Final Report - Corrections Required **Application No. DEPN-26-0013**

Description : Development Plan to establish internal roadways and lots. No end-users are proposed with this development plan application.

Address : 0 BRADLEY RD Colorado Springs CO

RAY CHARLES COMMERCIAL CENTRE
DEVELOPMENT PLAN
STORM PLAN

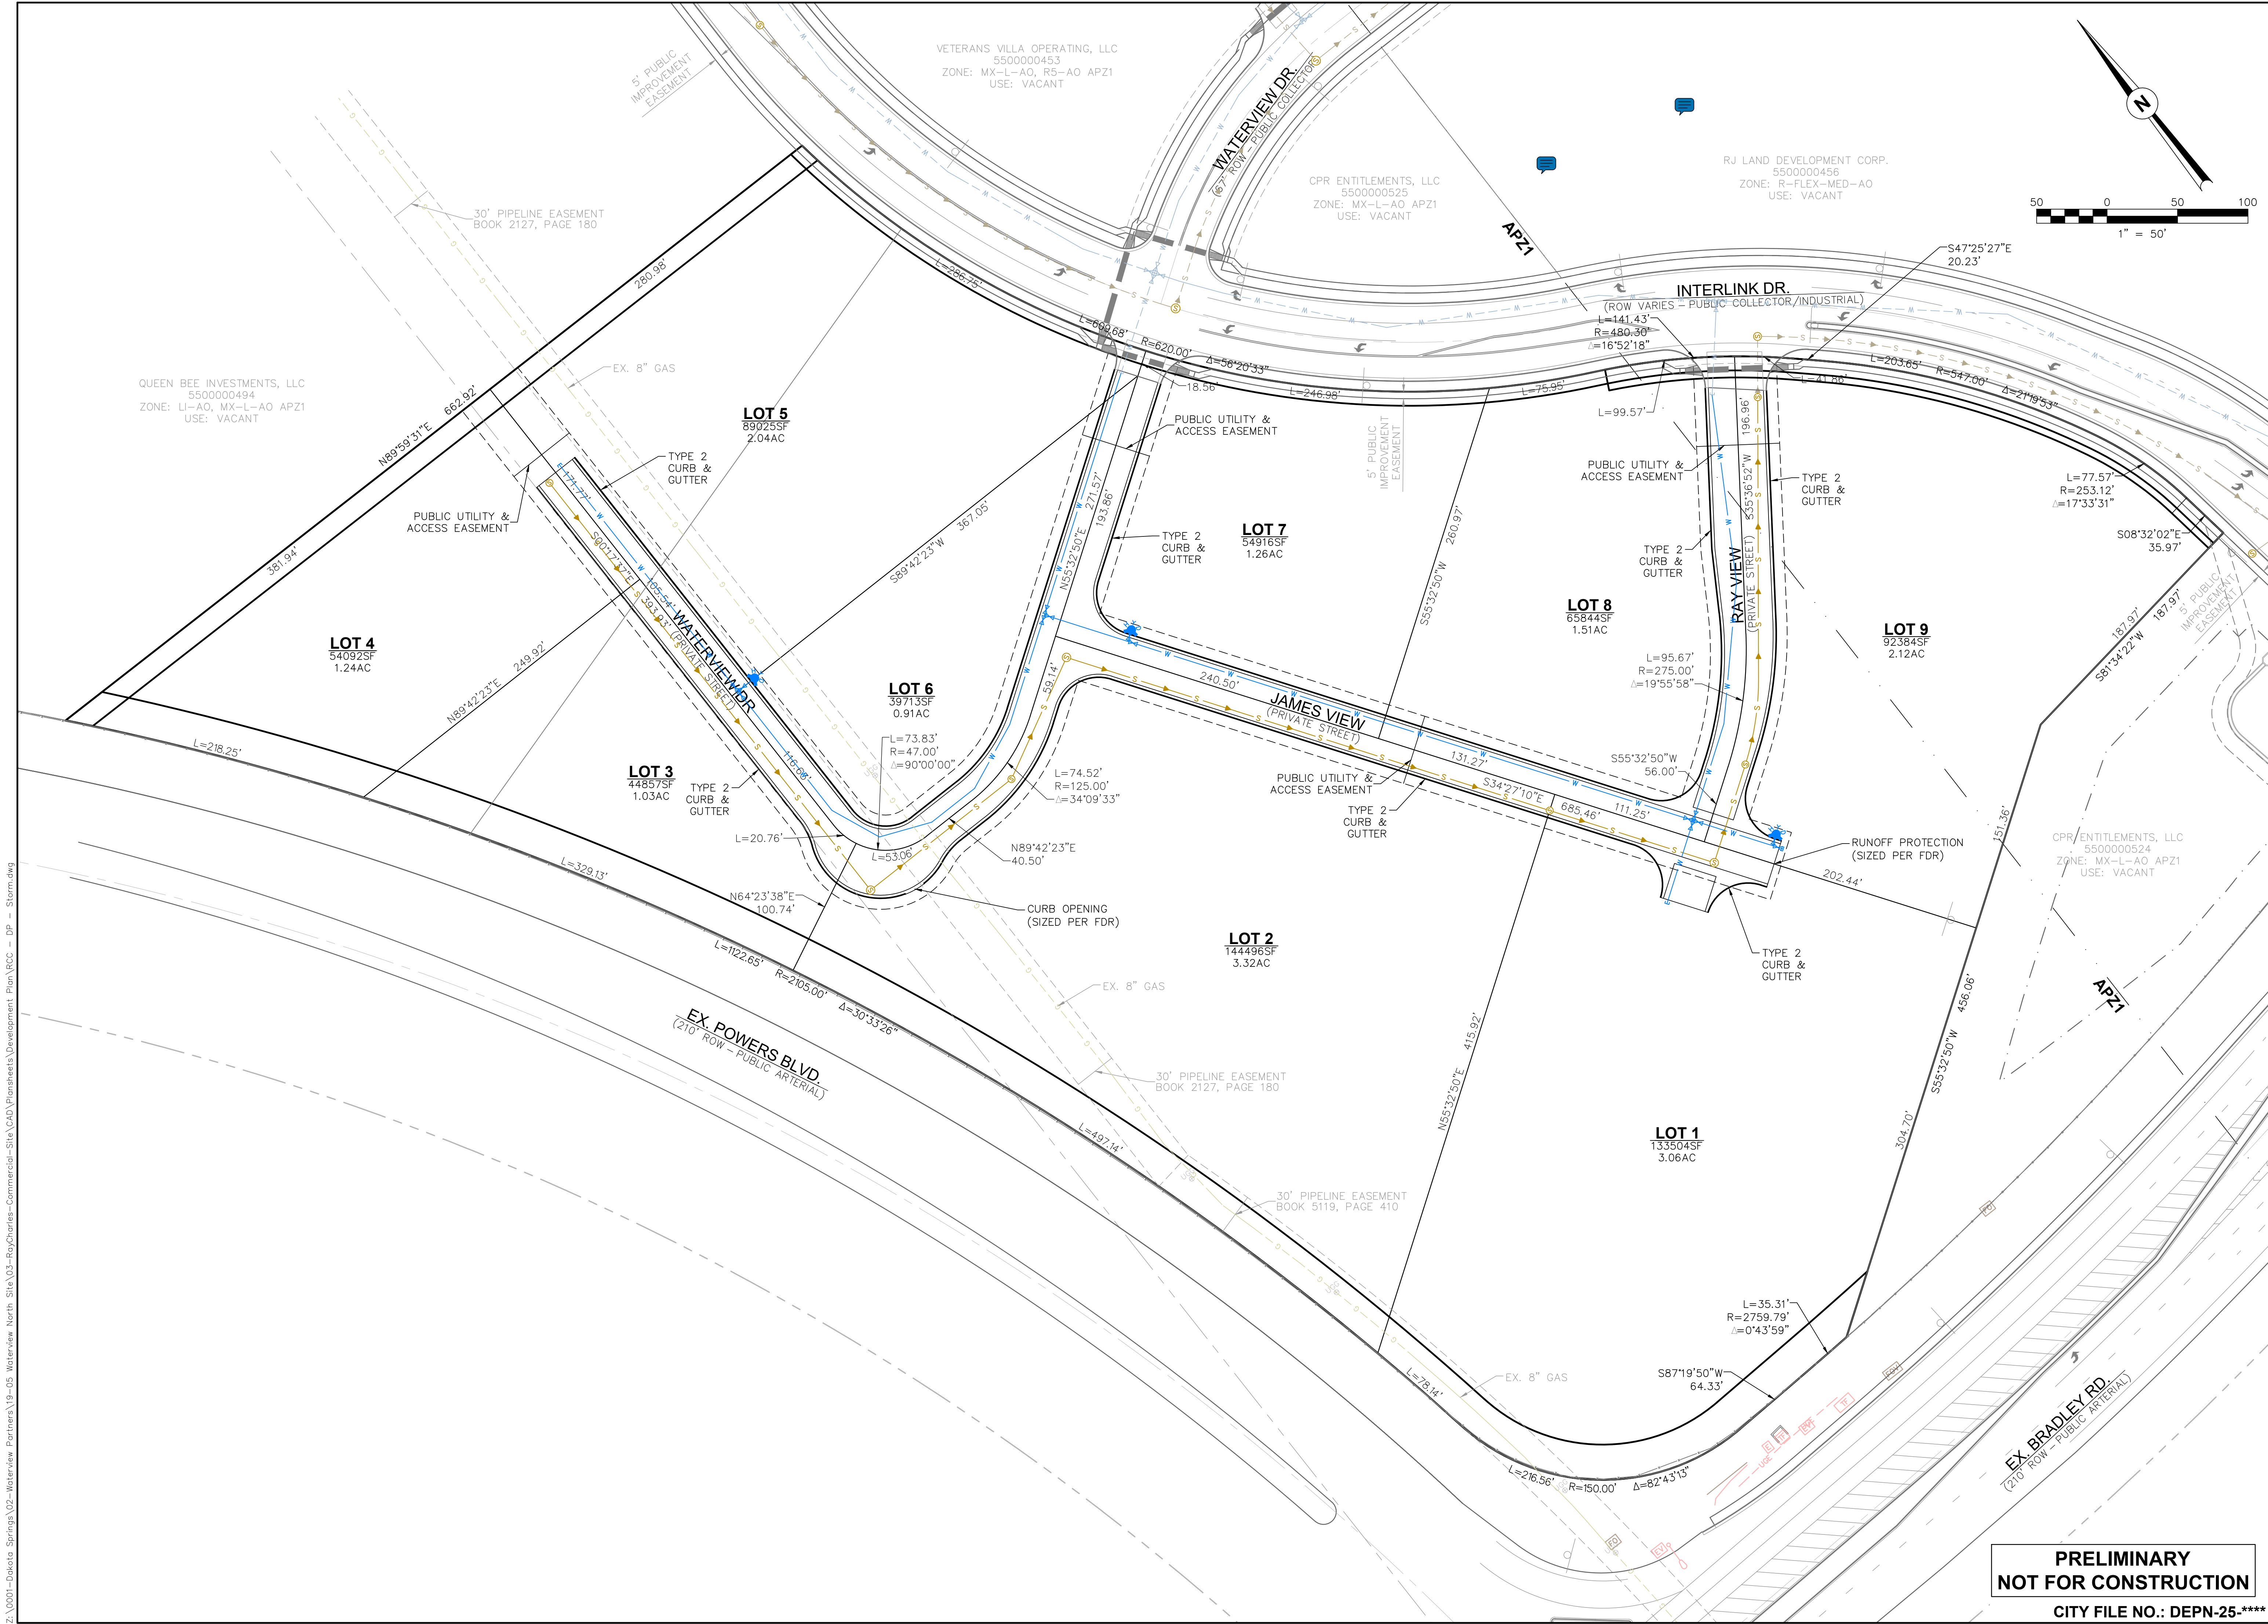
45	4	Sara Rivera : City Engineering - SWENT	Label all existing and proposed drainage infrastructure with size and ownership (private or public).
46	4	Sara Rivera : City Engineering - SWENT	Info Only: Construction Plans for the proposed storm sewer larger than 12" will need to be submitted to Engineering Development Review and Stormwater Enterprise for review and approval prior to construction.
40	3	Sara Rivera : City Engineering - SWENT	Add a note that all private to public storm sewer connections must be inspected by an Engineering Development Review Inspector.
47	5	Sara Rivera : City Engineering - SWENT	The offsite disturbance associated with utility installations must be included in the total disturbed area. In the FDR, areas of disturbance for offsite utility installation can be excluded from the total disturbed area as it applies to the Four Step Process, but this exclusion must be clearly documented. Please reach out to the Lead Reviewer if there are questions on how to show this. For the GEC and CWMP this disturbed area must be shown and included. This area cannot be excluded in these plans/reports.
